82 NW 5<sup>th</sup> Avenue  
(West Settlers Office Building)

Architect's Project Number: 200818

Addendum Number 2  
Issued: January 29, 2010

**SSK-1**

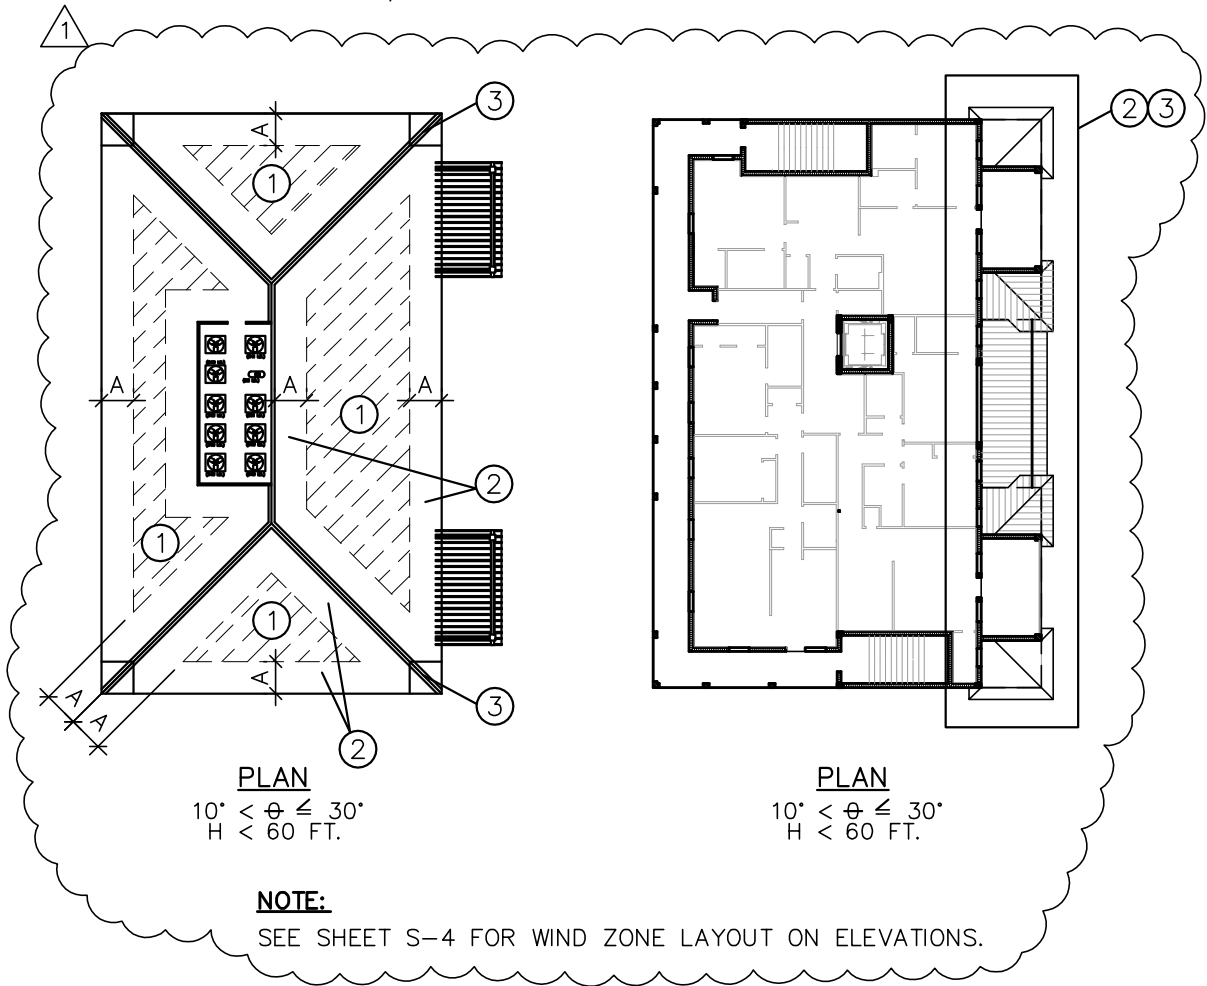
Item No. 13. **Sheet A-2 and S-2:** Balconies to be wood framed with Tongue and Groove deck, plywood sheathing and roof system (Modified Bitumen over Balconies 304K and 306N and Standing Seam Metal Roof over 233). See Attached sketches Ssk-1, Ssk-2, Ssk-3 and Ssk-4.

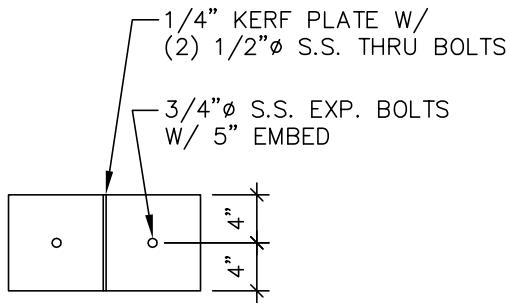
- Item No. 4. **Specification Section 07511 - Built-up Coal Tar Roofing: Delete and replace with Section 07551 MODIFIED BITUMINOUS MEMBRANE ROOFING. Refer to SSK-2 for required pressures**

WIND LOAD SCHEDULE					
COMPONENTS & CLADDING	ROOF WIND LOADS			WALL WIND LOADS (SEE NOTE 1)	
	ROOF AREA			WALL AREA	
	1	2	3	4	5
PRESSURE (PSF)	30.2	30.2	30.2 <sup>1</sup>	52.6	52.6
SUCTION (PSF)	-48.1	-83.7	-83.7	-56.9	-70.3
